**Exception Request No.: 140**  
**Section: WMNF**  
**Town: Easton**  
**Highway: NH 116 (Easton Road) (Tier 3)**  
**Station: 836+75 to 840+75; 838+25±**  
**Drawing No.: WMNF C115 to C116**  
**Survey Report Cross Reference No.: WMNF C115 to C116**  
**Exception Type: Alignment in Pavement**  
**Crossing Over Existing Drainage Structure**

EXCEPTION 140-ALIGNMENT IN PAVEMENT AND CROSSING OVER EXISTING UTILITY/DRAINAGE: NPT WMNF-UNDERGROUND ALIGNMENT WMNF SECTION-STA. 836+75 TO STA. 840+75±  
SCALE: H. 1"=30', V. 1"=10'  
DATE: 05/20/17

**TITLE:**  
 EXCEPTION 140  
 ALIGNMENT IN PAVEMENT  
 NPT-WMNF UNDERGROUND ALIGNMENT  
 WMNF SECTION-STA 836+75 TO STA 840+75±  
 TOWN: EASTON

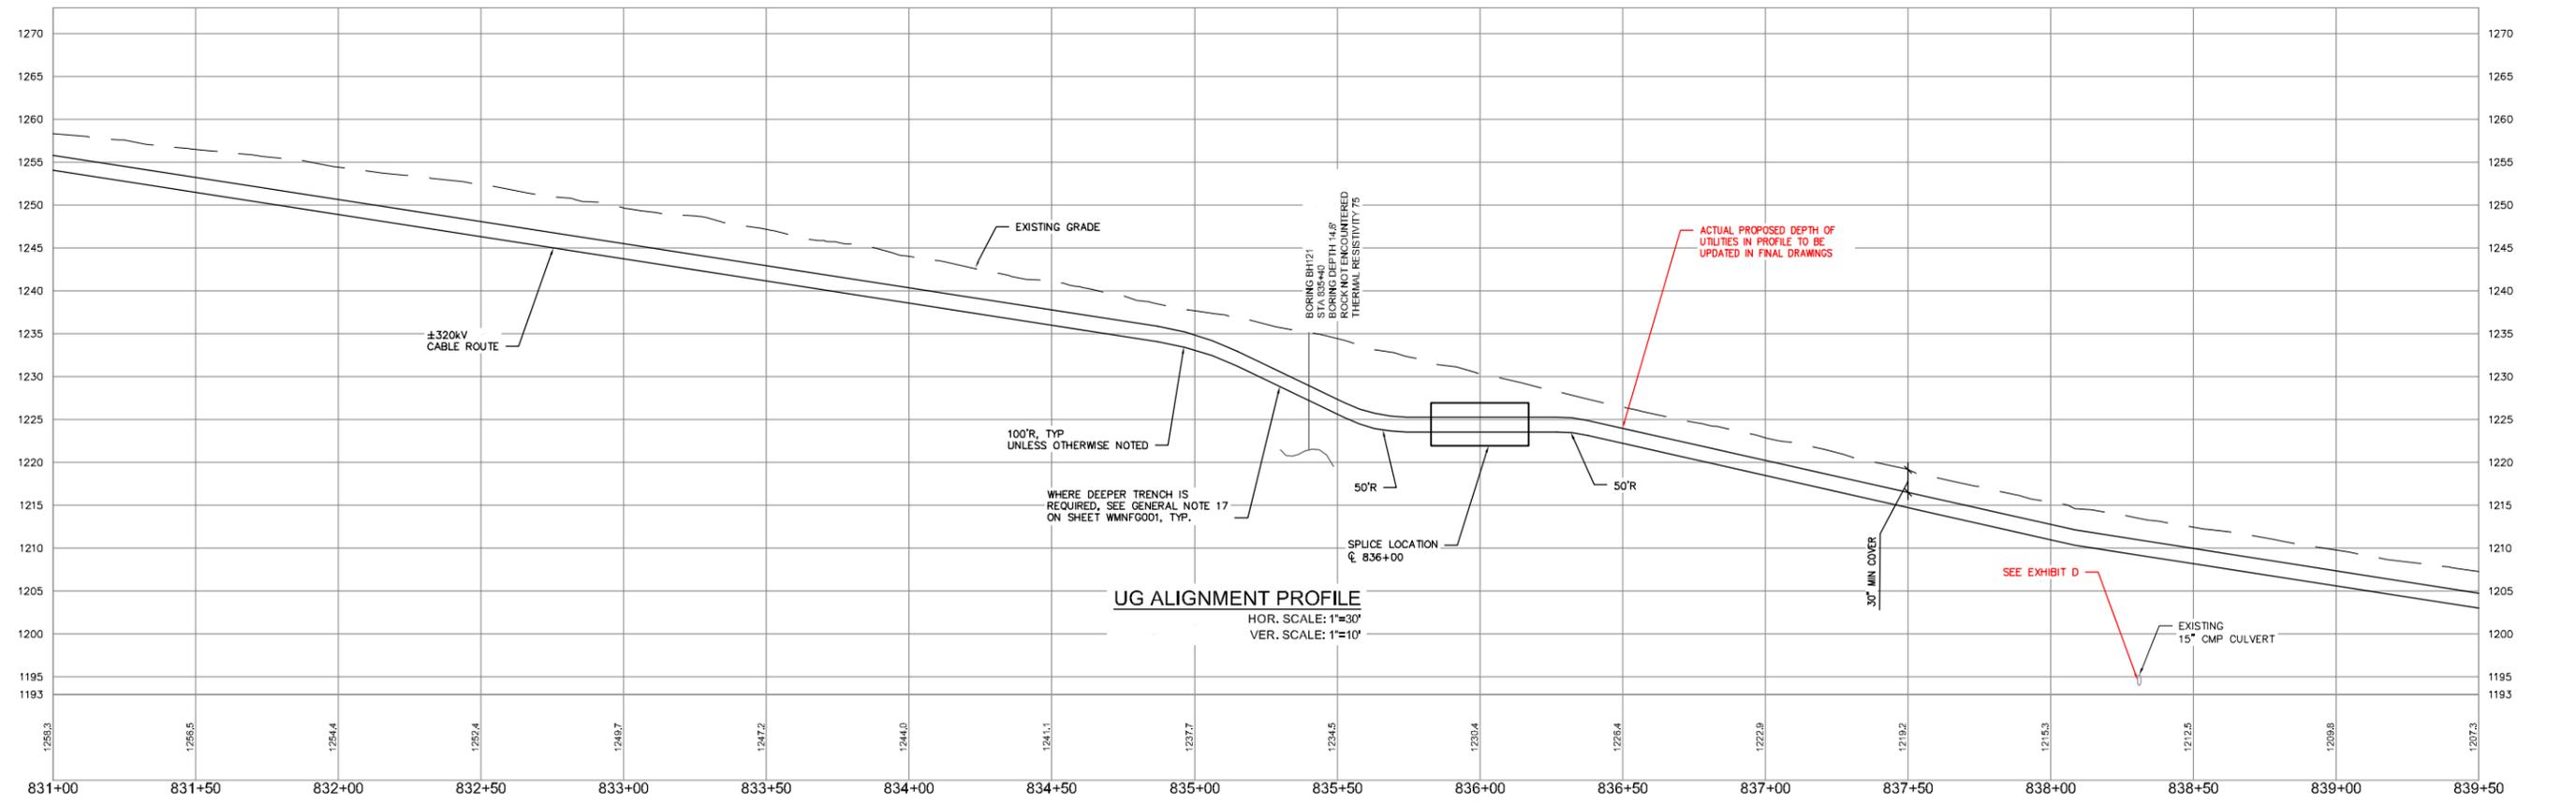
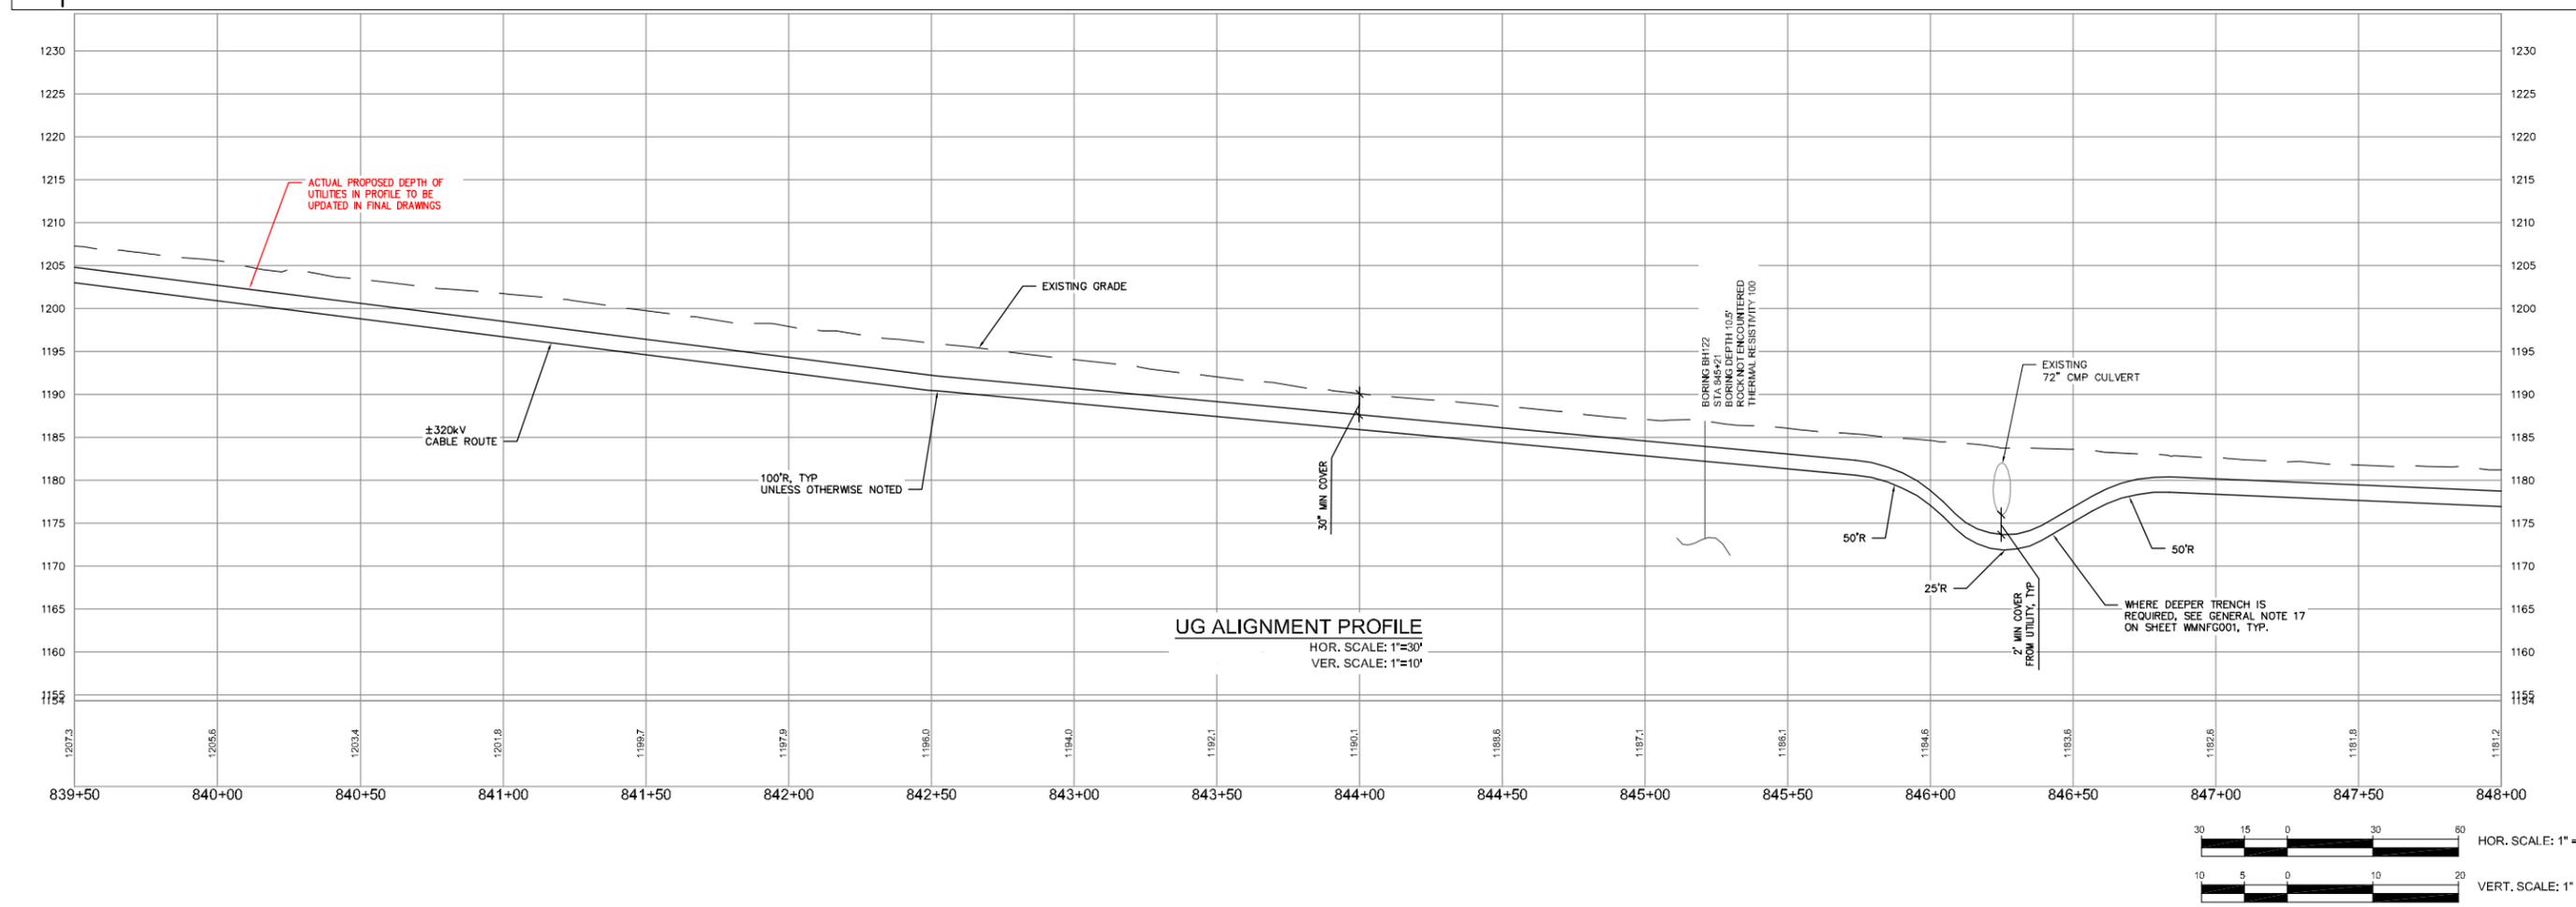
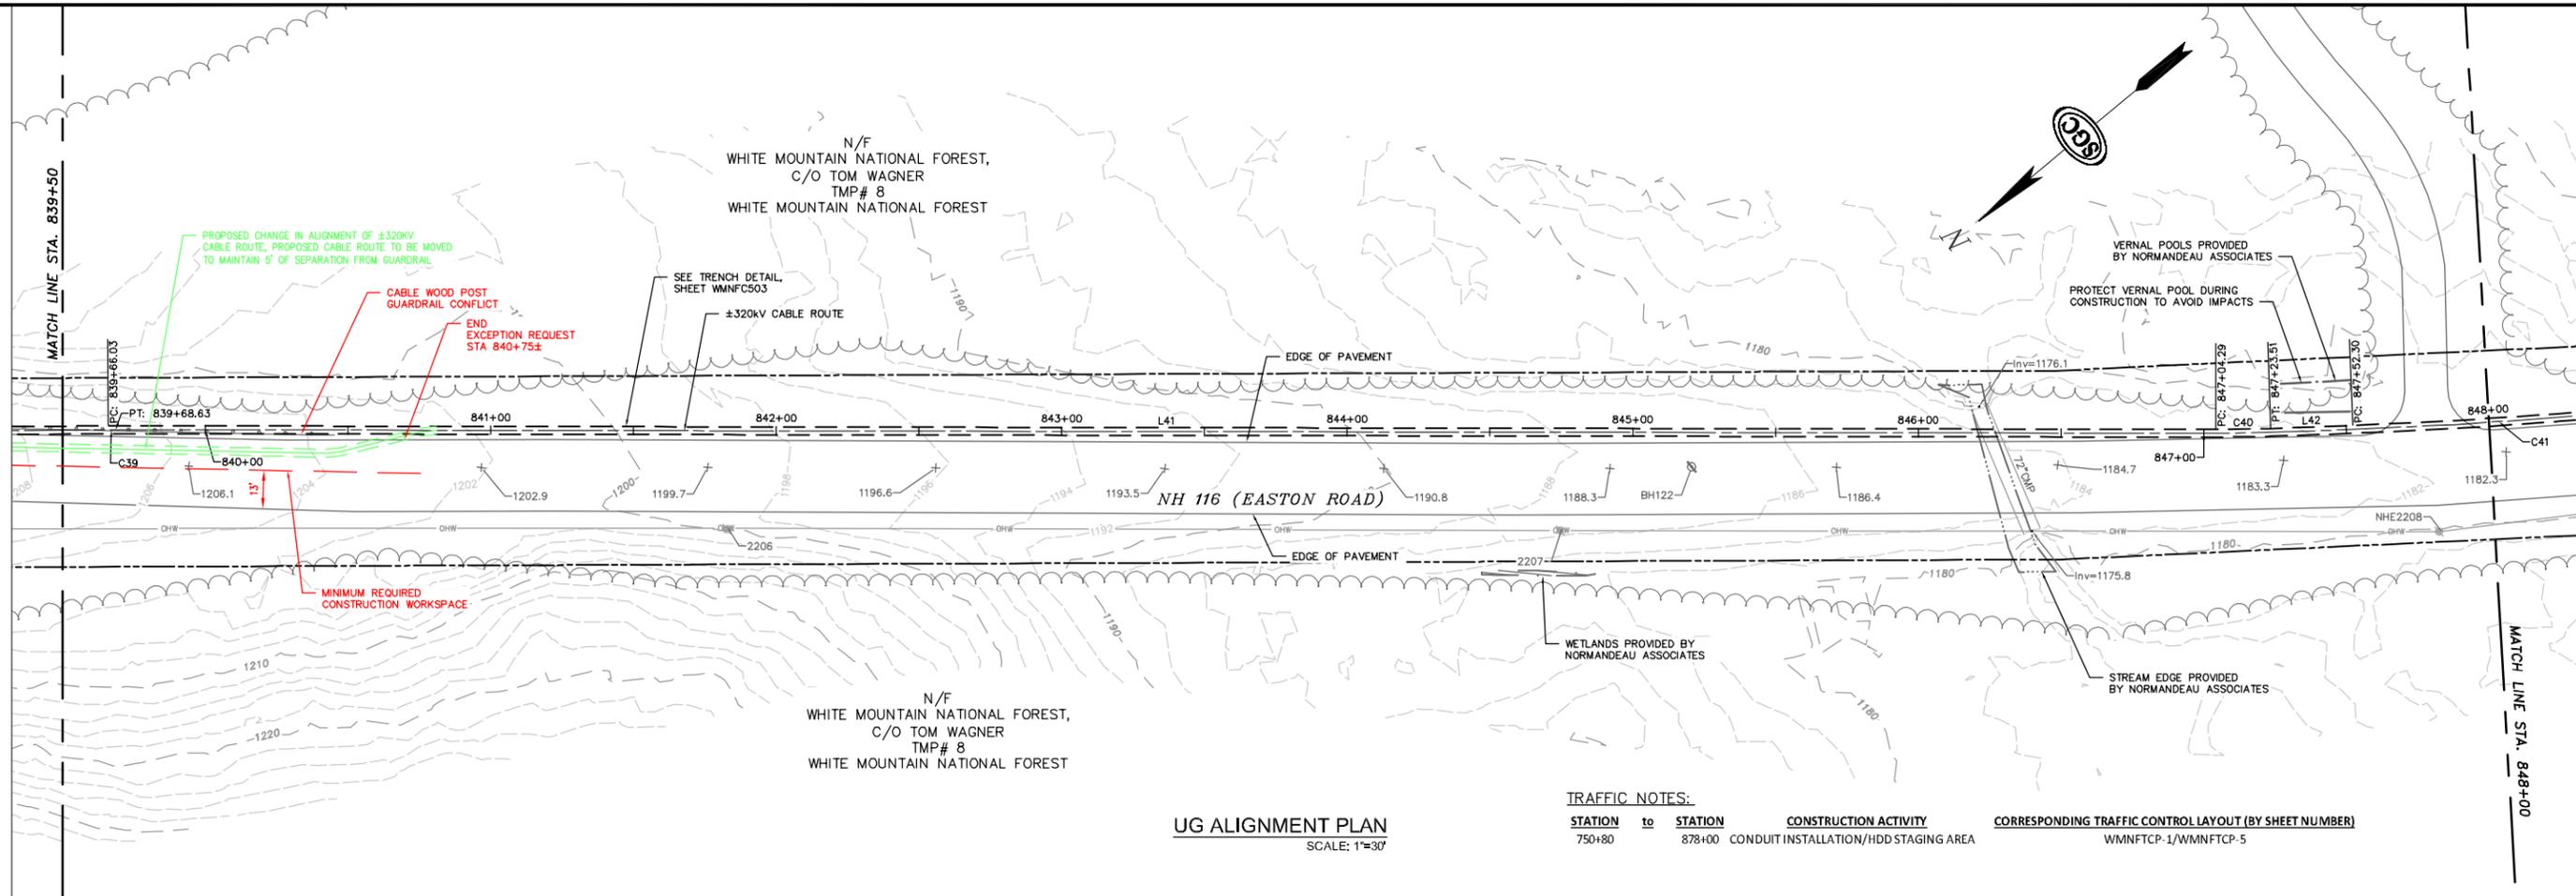
NPT is requesting an exception from the UAM guidelines for the location of the duct bank in the pavement on NH 116 from STA 836+75 to STA 840+75 due to constraints caused by a guardrail. (See Exhibit A.) The attached Exhibits have been provided to demonstrate that construction outside the guardrail is not practicable at this location.

The roadway alignment at this location is constrained by guardrail on the east side of NH 116, with slopes on the outside of the guardrails. Consequently, the slopes behind the guardrail combined with NHDOT's requested offset of 5-feet from the existing guardrail would result in significant constructability issues, including the need for benching into the side slope to create a level and safe working area. The construction of a temporary access road and reconstruction back to its original state would extend the duration of construction and create a greater traffic impact.

NPT evaluated whether it could relocate the alignment outside the pavement, but has determined it could not because the modified side slopes required for construction would extend beyond the outer edge of the EIS Study Area. (See Exhibit B.)

The design, as proposed, will not adversely affect the design, construction, stability, traffic, safety, environmental commitments, maintenance, or operation of the highway. The alignment has been located 5-feet off the edge of the guardrail, to avoid future conflicts with guardrail repairs or replacement or disruption to the existing guardrail system. The installation of the duct bank and pavement restoration will be designed and constructed in accordance with conditions outlined in the NHDOT’s April 3, 2017 letter to the New Hampshire Site Evaluation Committee. The installation’s proposed depth meets NHDOT’s criteria relating to the structural box to minimize any potential conflicts with maintenance and future highway projects. A traffic control plan has been submitted to the NHDOT for this design and complies with the Manual on Uniform Traffic Control Devices.

## SECTION A-A

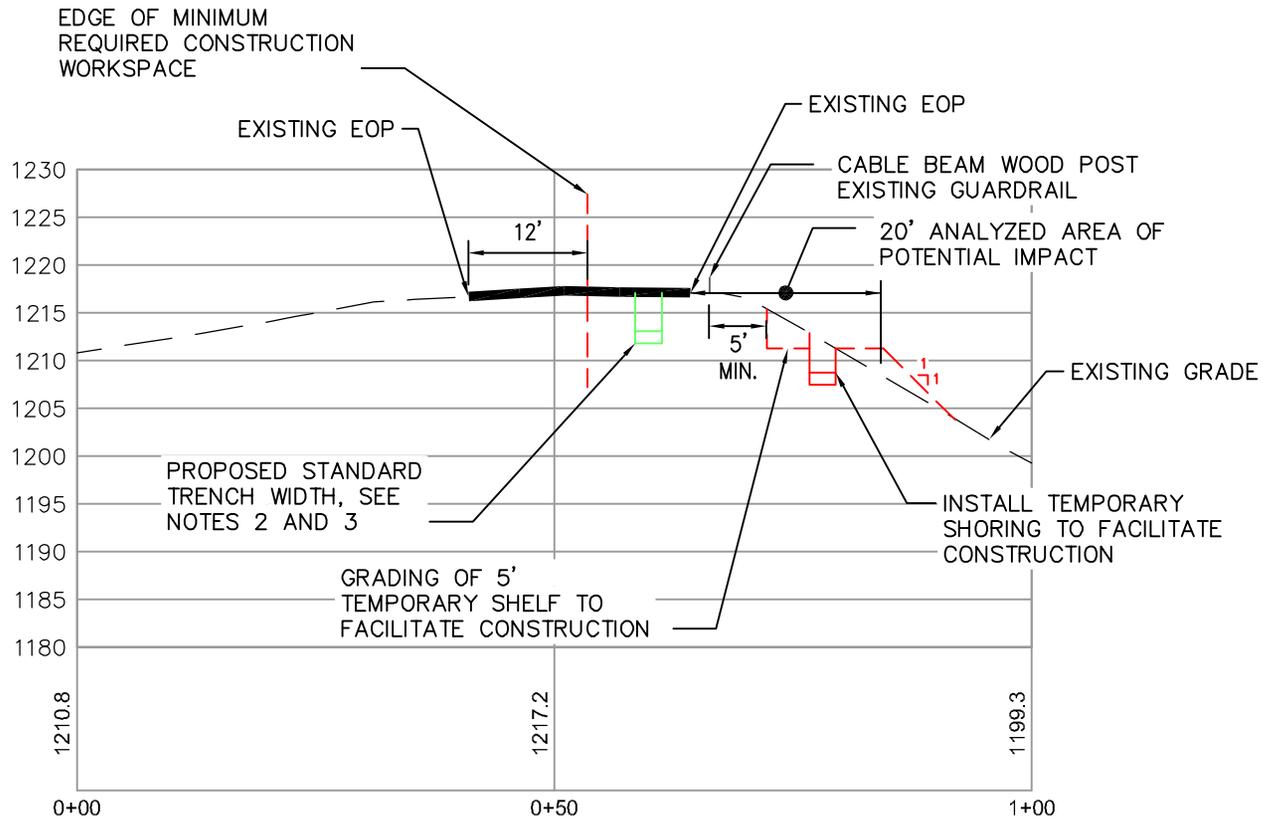
NPT also evaluated an option to remove the guardrail and a portion of the roadway to allow NPT to construct the duct bank in the slope without having to conduct work beyond the outer edge of the EIS study area. Although this option would allow NPT to restrict its work to the ROW, this alternative is not practical for several reasons. First, considerable amounts of materials would have to be removed and transported to another site for temporary storage in order to bench into the slope. These materials would then have to be transported back to the site to restore the site after the duct bank was completed. (See Exhibit C.) Second, this option would significantly increase the time necessary in the NHDOT ROW required to construct the duct bank and would be unreasonably costly, causing a net increase of \$53,452, including the cost of material transport and new guardrail installation. (See Exhibit E.) (Note: This marginal cost estimate does not factor in the potential that native materials cannot be used during reburial because more expensive, select materials may be needed to address cable thermal issues.) Finally, traffic impacts would be significantly greater for this option (as compared to the proposed installation) due to the additional work for the benching activities.

1. THE TRENCH LOCATION SHOWN IN RED IS NOT PROPOSED AND IS INTENDED TO DEMONSTRATE CONSTRUCTABILITY ISSUES.
2. TRENCH WIDTH SHOWN TO BE MAINTAINED USING TRENCH JACKS AND SHEETING.
3. PROPOSED CABLE ROUTE TO BE MOVED TO MAINTAIN 5 FEET OF SEPARATION FROM THE GUARDRAIL. A MINIMUM 12-FOOT WIDE TRAVEL LANE WILL REMAIN TO MAINTAIN A SINGLE LANE OF TRAFFIC.

**SECTION C-C**  
SCALE: 1"=20'

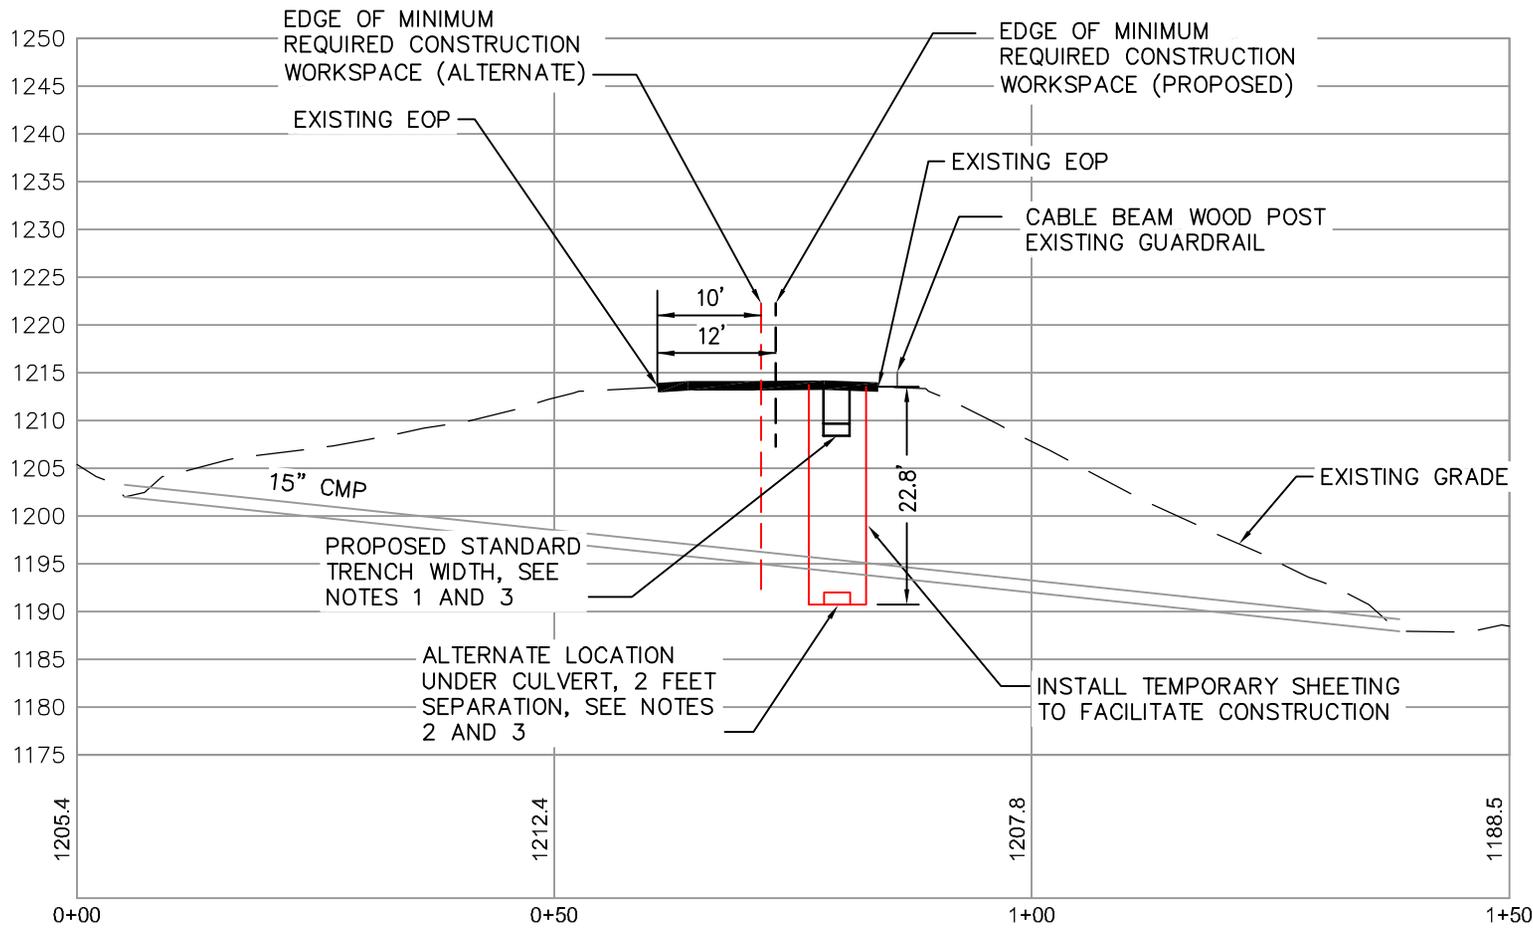
The vertical positioning of the cable trench is constrained by the depth of the existing culvert (18 feet to the top of the culvert). (See Exhibits A and D.) Crossing under the existing culvert and meeting the required 2-foot minimum separation will require a wider trench as the thermal design criteria require a greater separation of the electrical cables as depth increases. This trench width and additional offsets necessary for construction would likely require either complete road closures or result in significant traffic impacts, including extended duration of construction within roadway to allow for sheeting installation and removal and extensive excavation due to the depth and width of the trench. We estimate that these construction alternatives will add 2-3 weeks to the traffic impacts. Finally, we estimate the increase in cost associated with crossing underneath the culvert would be approximately \$248,000 for this 200 foot section. (See Exhibit E.) Road closures are not needed for the proposed installation, which thereby minimizes traffic impacts and attendant safety issues.

We have also evaluated a trenchless option to pass under the culvert. The trenchless installation will be unreasonably costly (a net estimated increase of \$2,069,100 for the 15-inch culvert crossing section). (See cost estimate attached in Exhibit E). Also, traffic impacts would be increased for a trenchless installation due to the addition of trenchless work areas and the extended duration of installation.

At all locations where the new duct bank is constructed over an existing drainage structure or utility, NPT will encase the facility in a concrete duct bank reinforced with rebar for a length to exceed a 2:1 slope from the bottom/center of the drainage structure (or utility) to the surface. At a minimum, this will involve a 20-foot reinforced section on each side of the crossing to form a self-sustaining bridge that will allow for excavation under the duct bank for purposes of future maintenance of existing utilities or drainage structures. This reinforced concrete duct bank shall be designed by a Professional Engineer licensed in the State of New Hampshire. In connection with future maintenance activities, especially related to the culvert, NPT will provide any and all required support, including but not limited to, providing crews to assist while work is being conducted in the vicinity of the culvert.

- NOTES:
1. THE TRENCH WIDTH SHOWN TO BE MAINTAINED USING TRENCH JACKS AND SHEETING.
  2. TRENCH WIDTH SHOWN TO BE MAINTAINED USING TRENCH BOXES.
  3. PROPOSED CABLE ROUTE TO BE MOVED TO MAINTAIN 5 FEET OF SEPARATION FROM THE GUARDRAIL. CHANGE IN ALIGNMENT WILL PROVIDE ADDITIONAL ROOM FOR WORKSPACE AND MAINTENANCE OF TRAFFIC.
